State of New Mexico
 Energy, Minerals and Natural Resources

OIL CONSERVATION DIVISION
 1220 South St. Francis Dr.
 Santa Fe, NM 87505

SUNDRY NOTICES AND REPORTS ON WELLS
 (DO NOT USE THIS FORM FOR PROPOSALS TO DRILL OR TO DEEPEN OR PLUG BACK TO A DIFFERENT RESERVOIR. USE "APPLICATION FOR PERMIT" (FORM C-101) FOR SUCH PROPOSALS.)

Wellbore Schematic
EverQuest Energy Corporation
Rancho Verde 10 State COM #1
 API# 30-025-34587

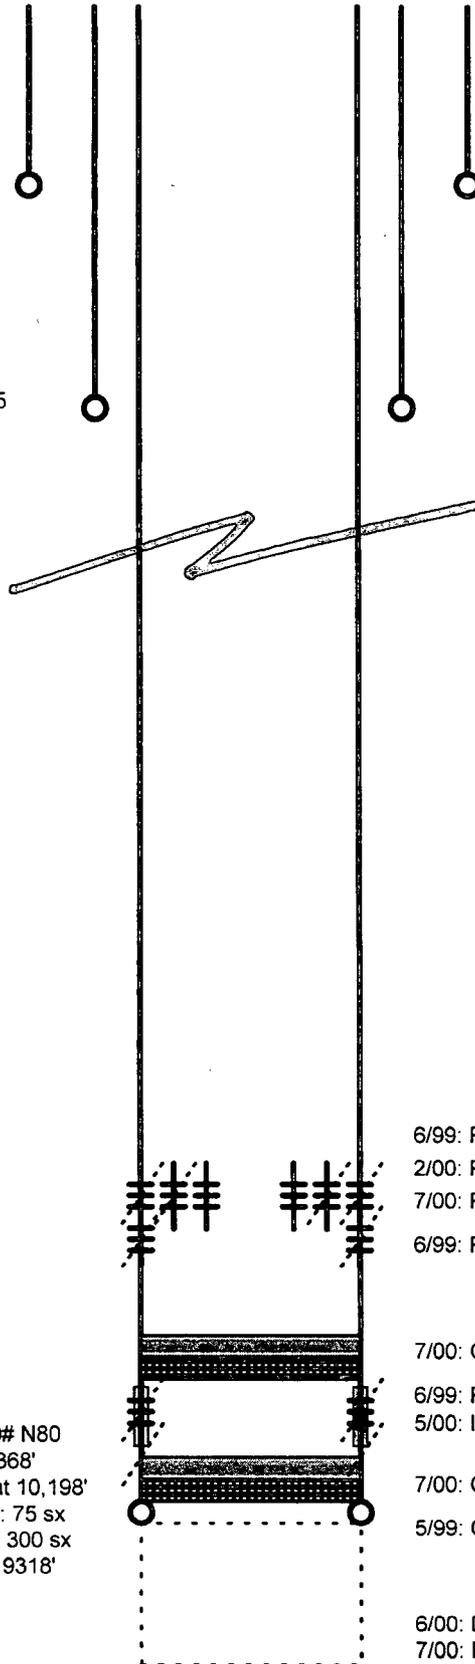
Well must be P/A'd 9750' TO SURFACE.
 AS PER APPROVED C-103 SUBMITTED 10/24/2014
 10 lb. Gel brine between all plugs
 NOT A STATUS WILL BE GRANTED!
 → 10/28/2014
